Amendment C131 – Land Subject to Inundation Overlay and Floodway Overlay

Peer Review Report

Report Reference: R.M00450.002.01_C131_Review.docx
Date: 28 September 2023
Prepared for: Latrobe City Council

Figure: **4-1**

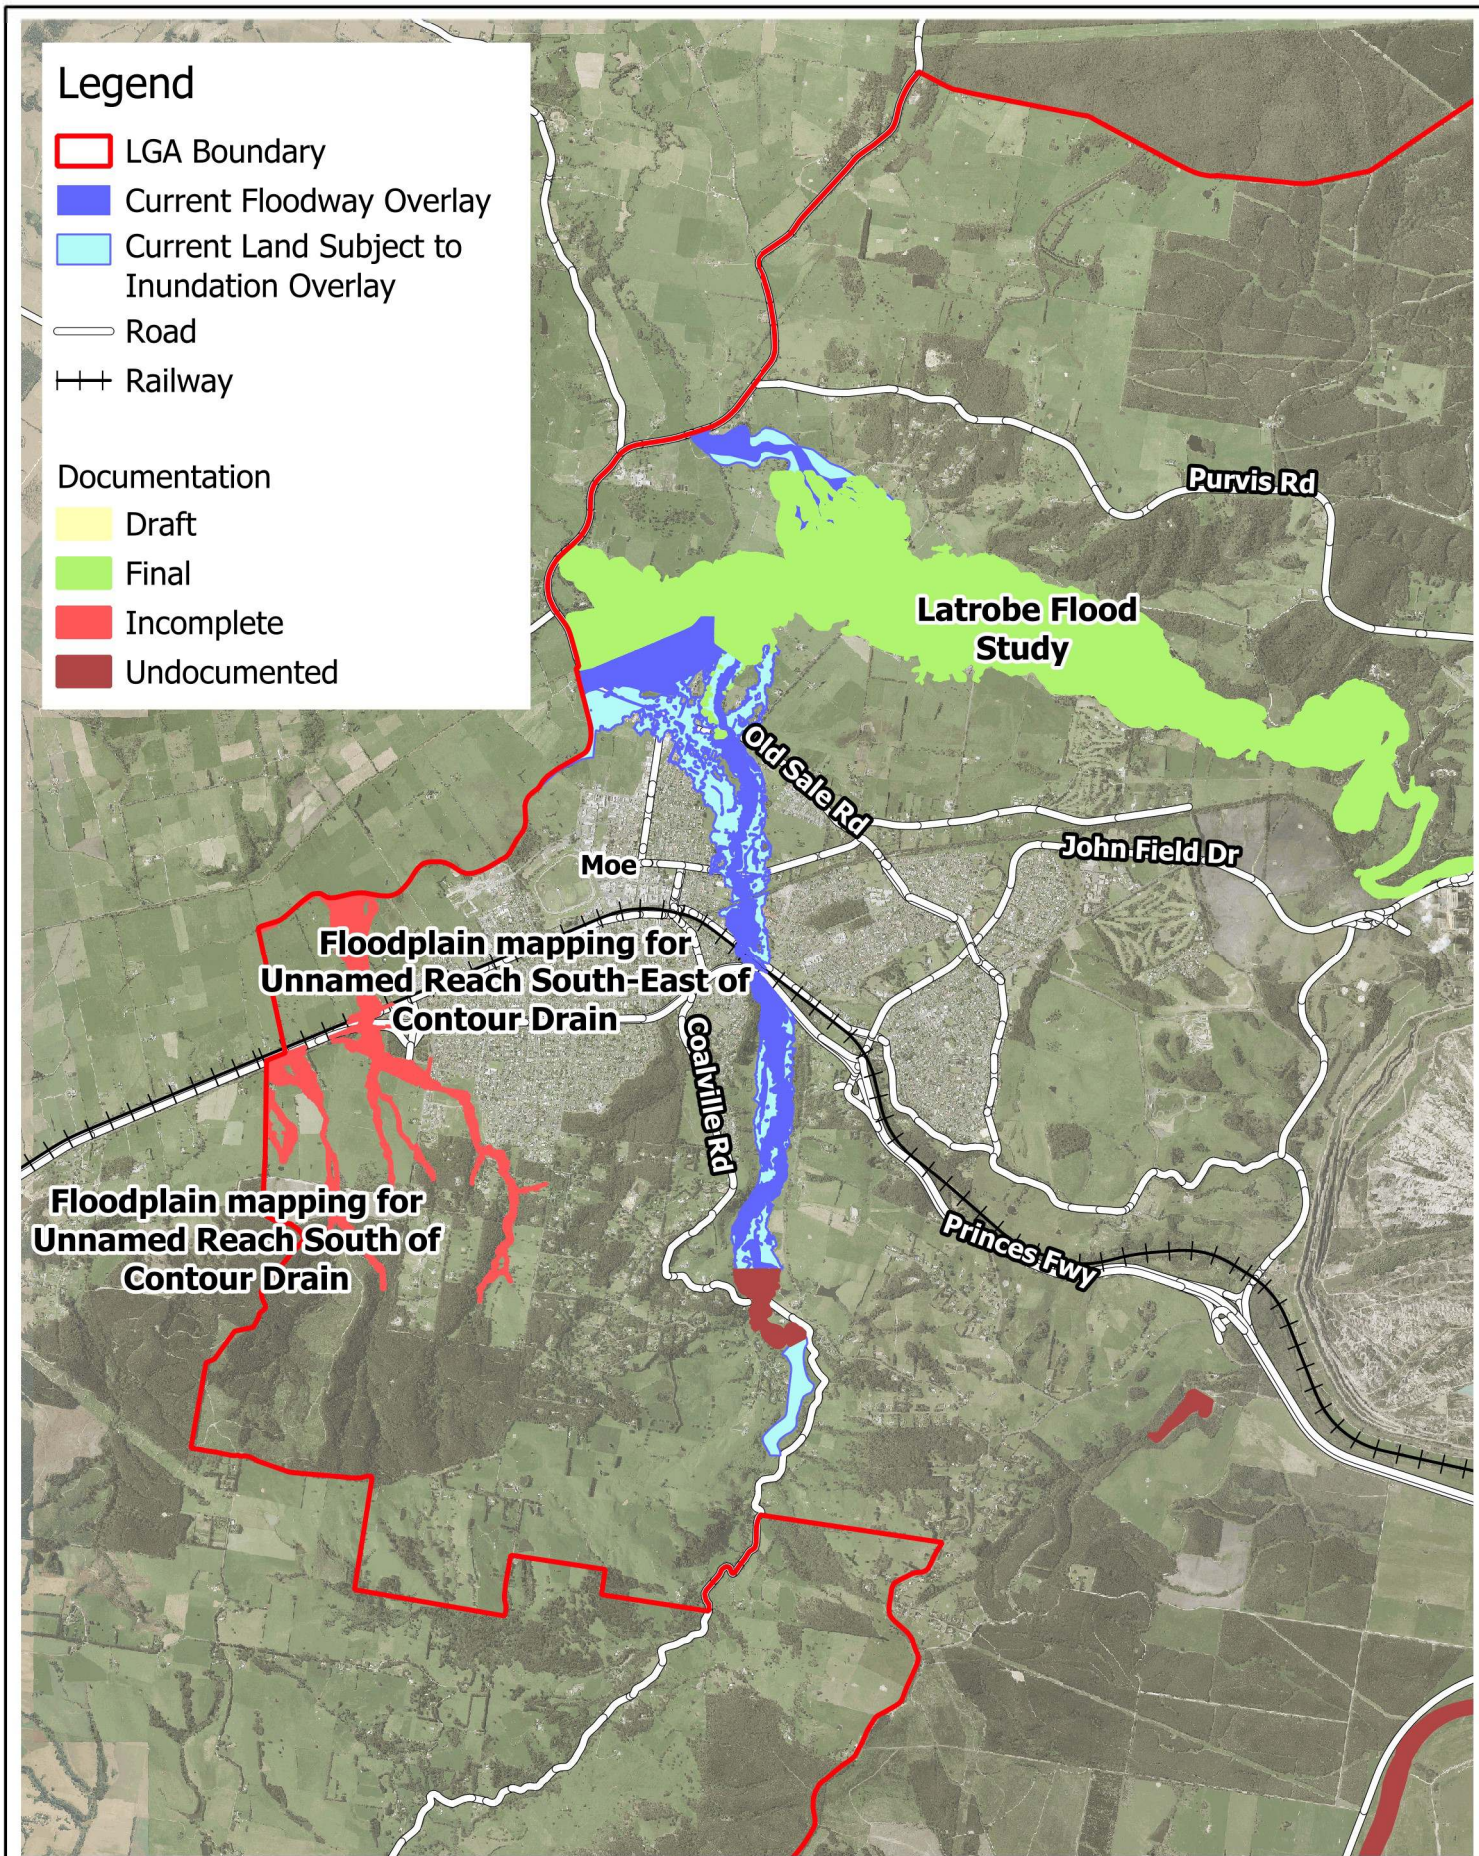
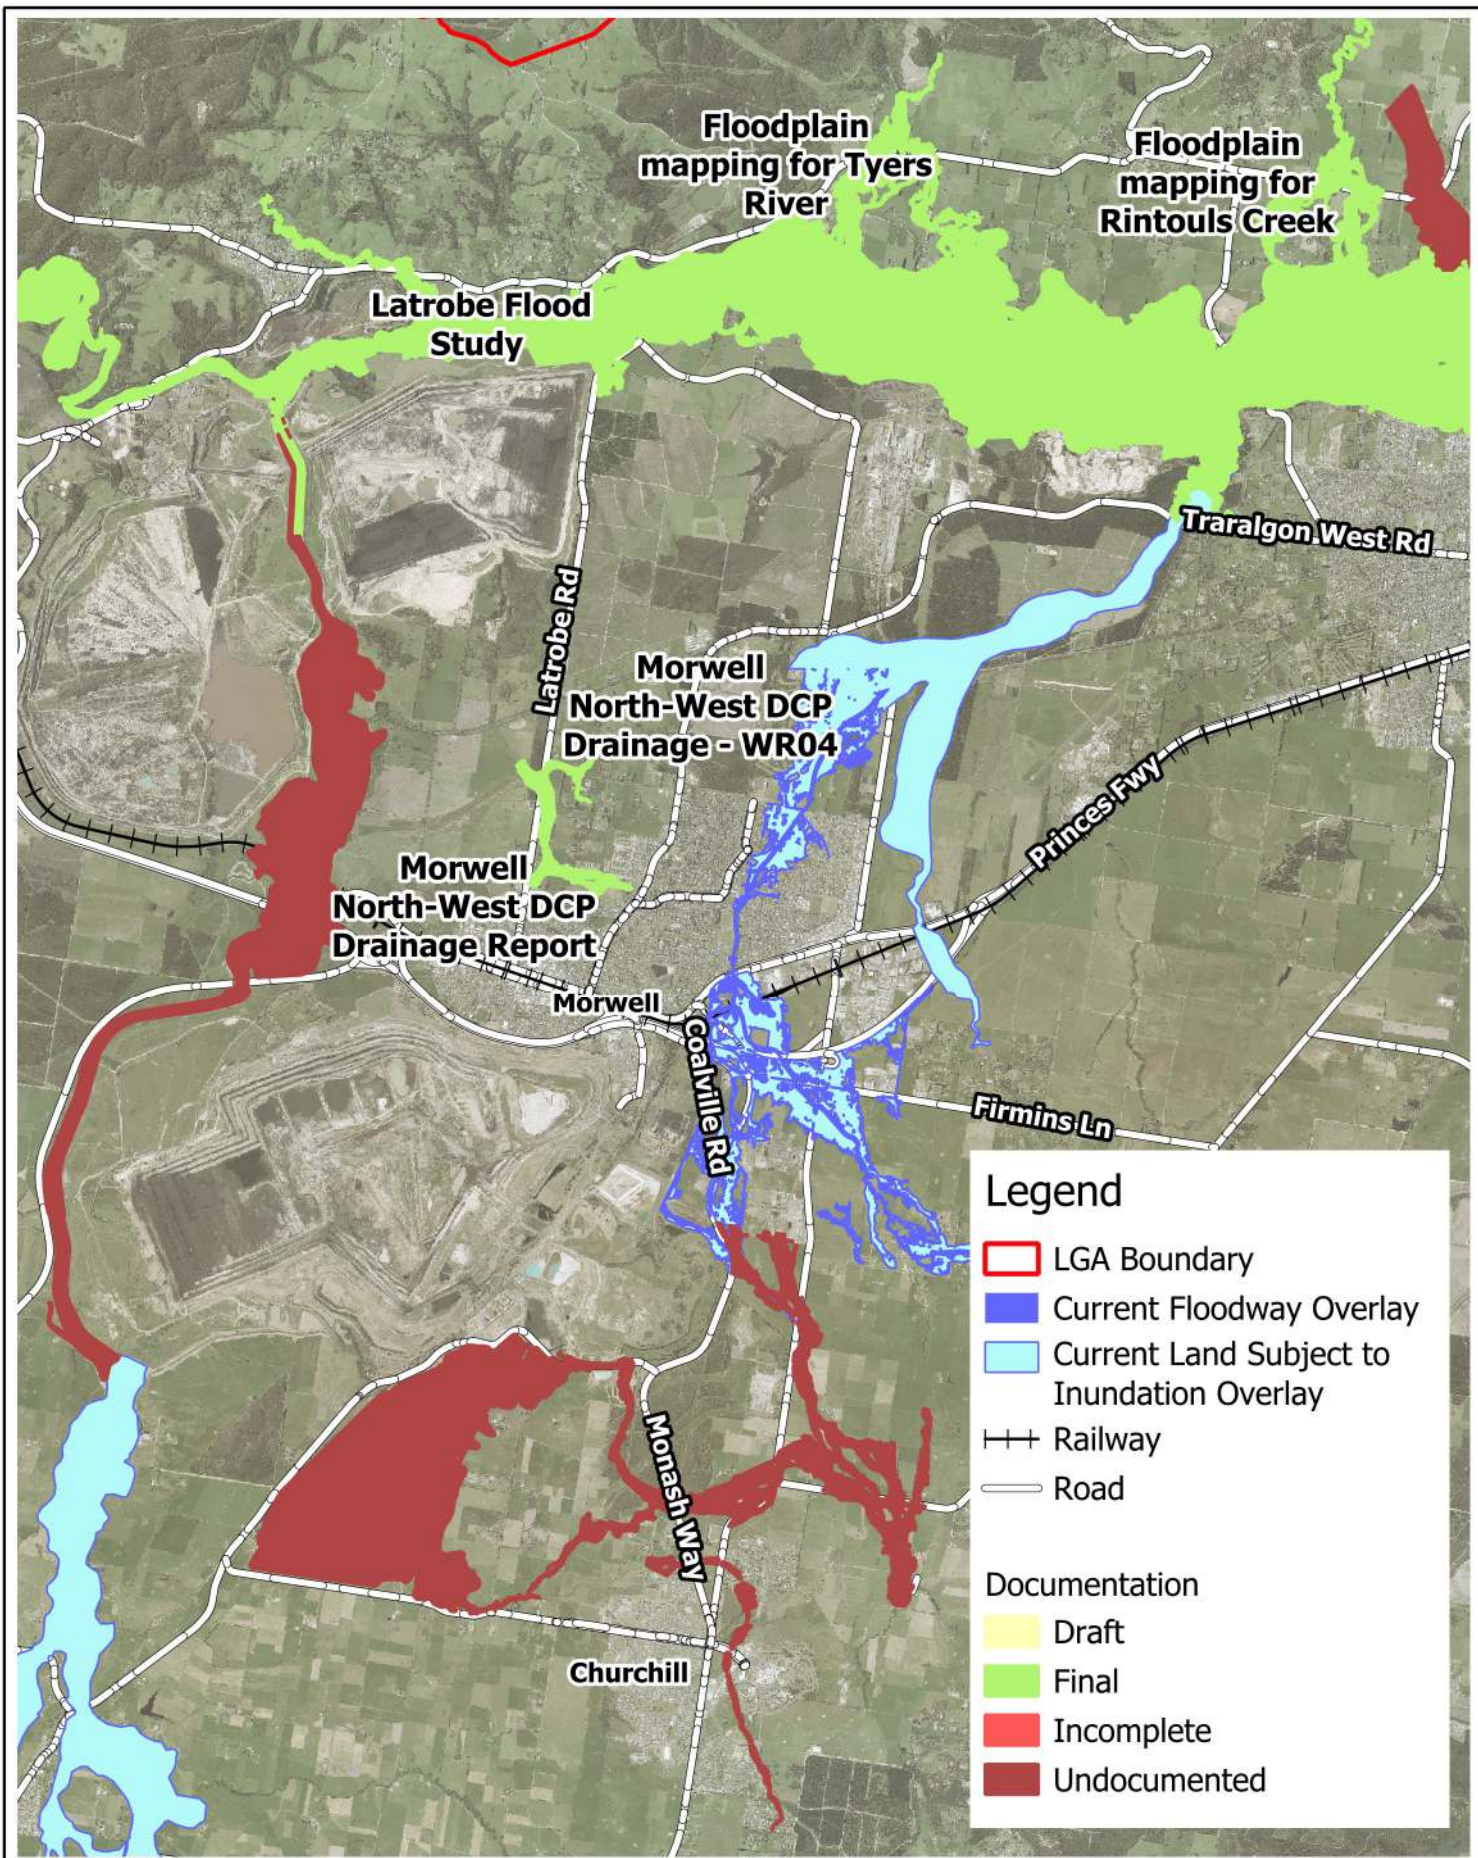
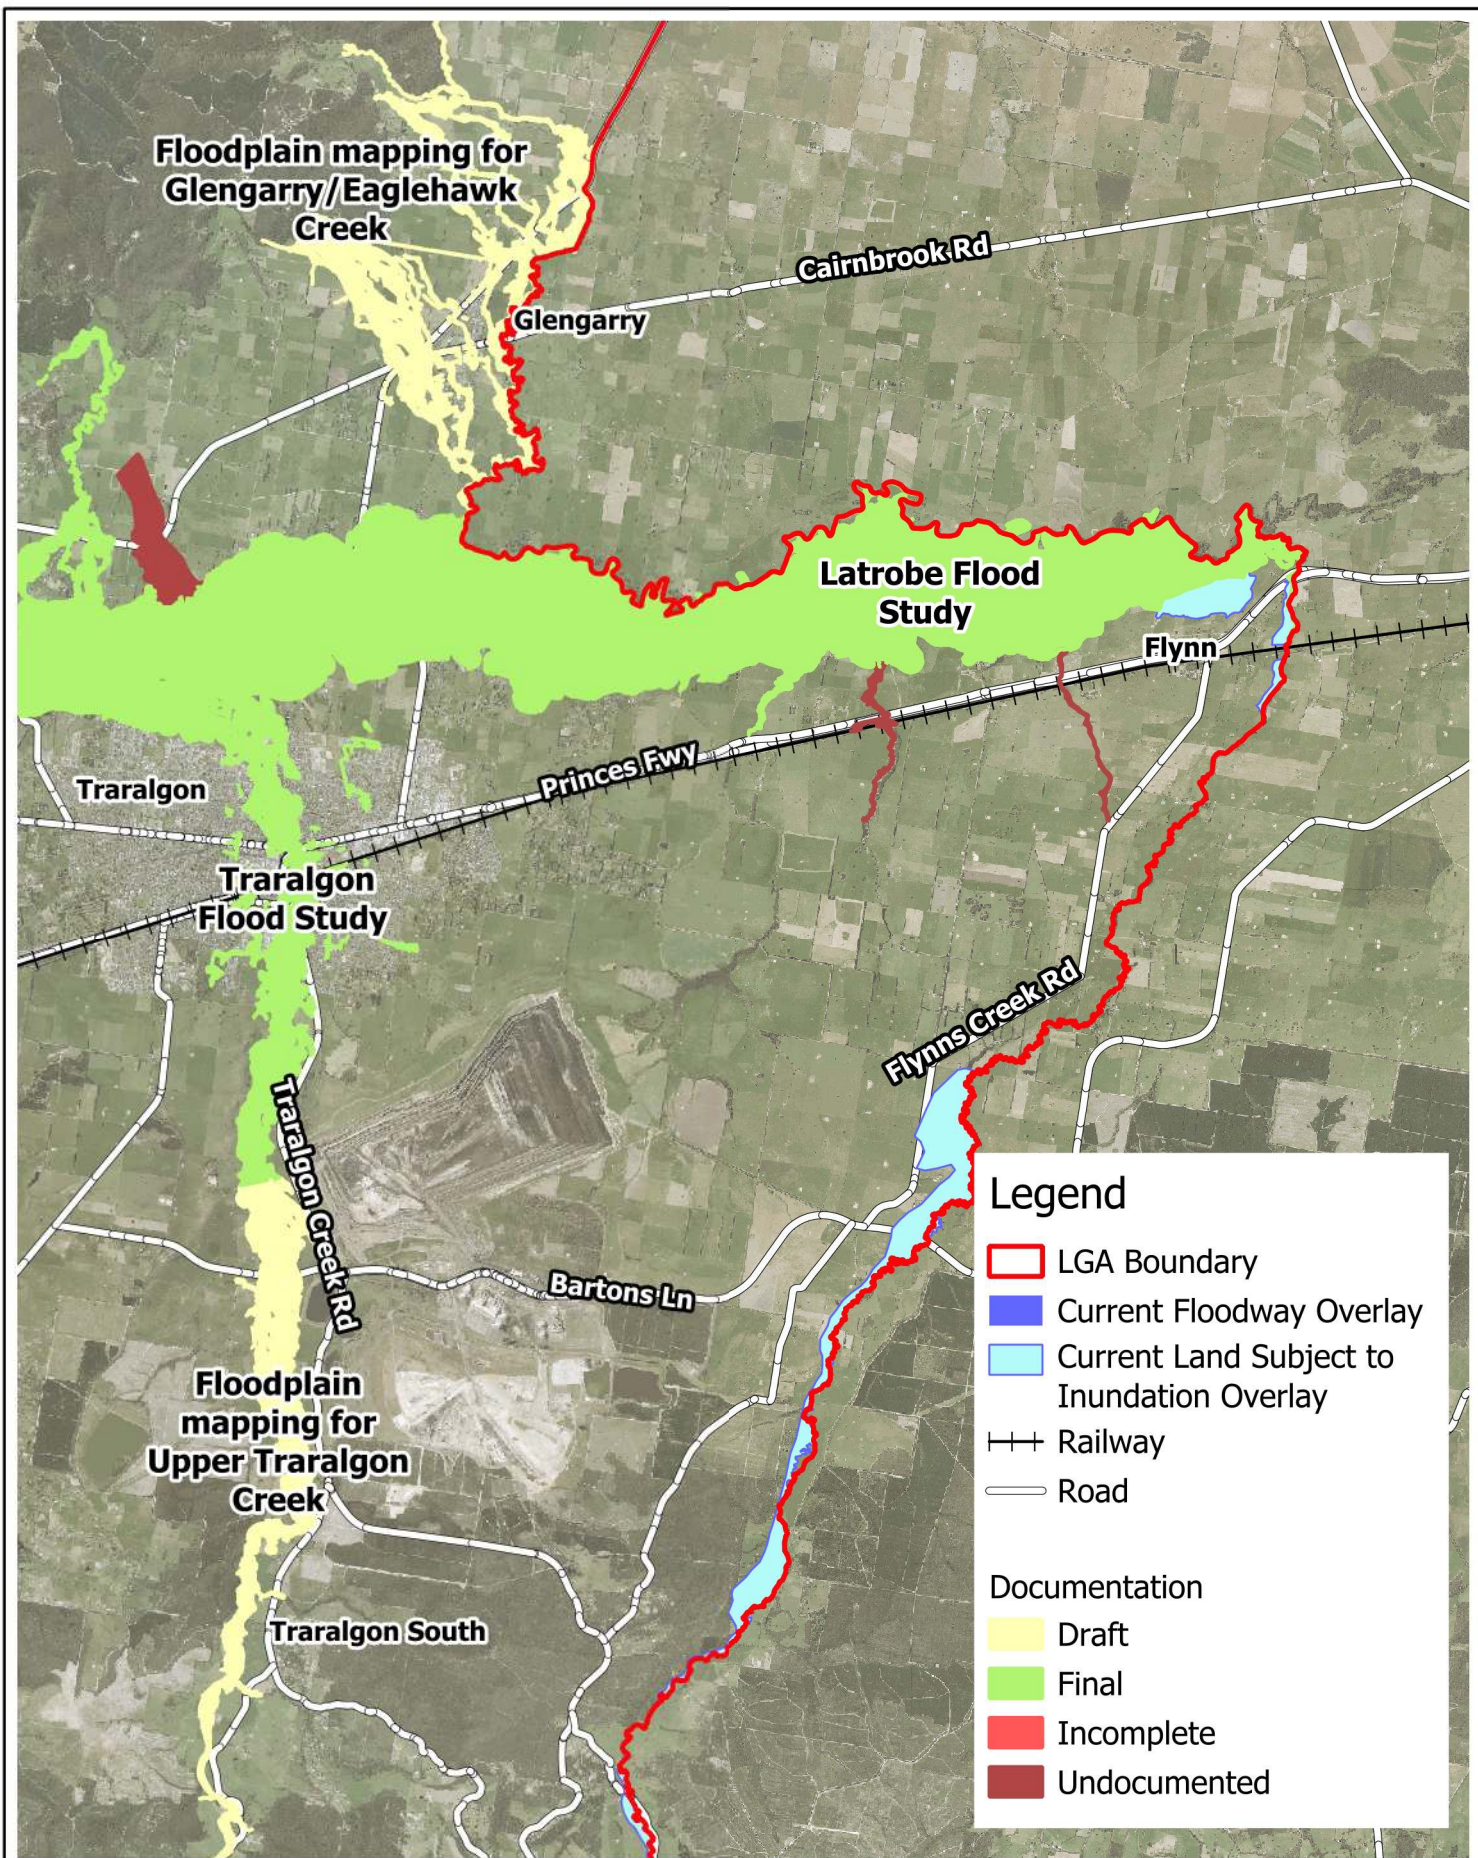
As listed in Table 4-2 and Table 4-3 and mapped in Figure 4-1, Figure 4-2 and Figure 4-3 there are several areas of Amendment C131 that are undocumented. These fall into two categories:

While the technical veracity of the flood modelling studies might be suitable for a planning scheme amendment and the mapping presents the best available flood risk information for that area, without documentation this cannot be confirmed. Our experience in providing expert witness services for these types of amendments is that the panel requires assurance as to the technical veracity of the modelling work informing the amendment. As such it was agreed during the workshop to not proceed with amendments not supported by documentation.

For the revisions made to the current overlays by WGCMA it was agreed during the workshop that reasoning and method behind these revisions would be documented in either a standalone technical report or the Amendment C131 Explanatory Report.

Figure 4-4 Example of flooding in urban area (Glengarry)

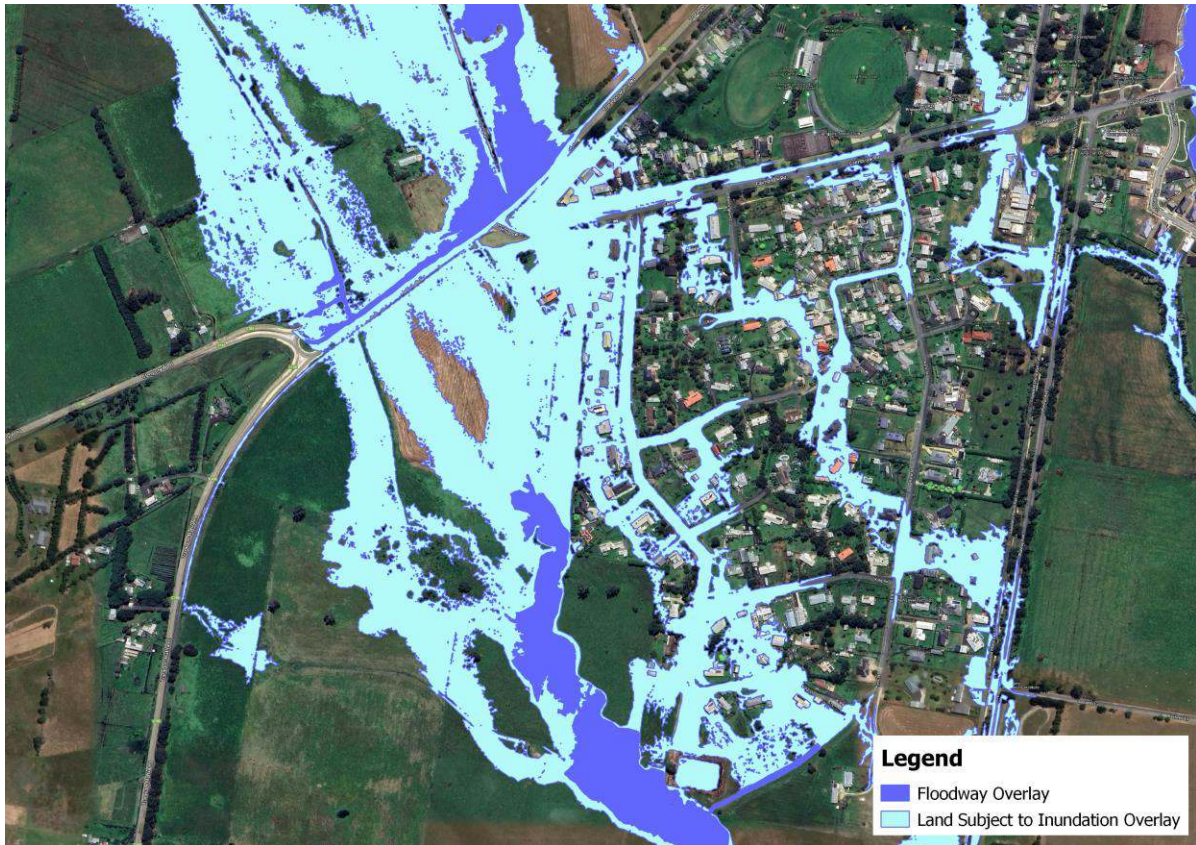
The Traralgon Flood Study is the only study included in Amendment C131 that represents overland flow originating from the capacity of the urban underground drainage network being exceeded and hence being appropriate to represent as SBO. As this area is currently subject to an urban flood mapping study it is recommended that these areas of flooding be removed from Amendment C131 and be incorporated in a future amendment as SBO (or LSIO) once the urban flood study is complete.

Other urban areas included in the overlays are from flood studies representing flooding originating from rivers, creeks, small watercourses and other overland flowpaths as opposed to the capacity of underground (pipe and pit) drainage systems being exceeded resulting in overland flow. As an example, while it is possible that undersized or blocked bridges, culverts and other drainage structures are contributing to the inundation in Glengarry (Figure 4-4), the flood model does not apply flow to the urban drainage network, rather all flow is applied to the watercourses and floodplain upstream of the township. Therefore while the mapped LSIO extends into the developed area the mechanism of this inundation is consistent with LSIO as opposed to SBO.
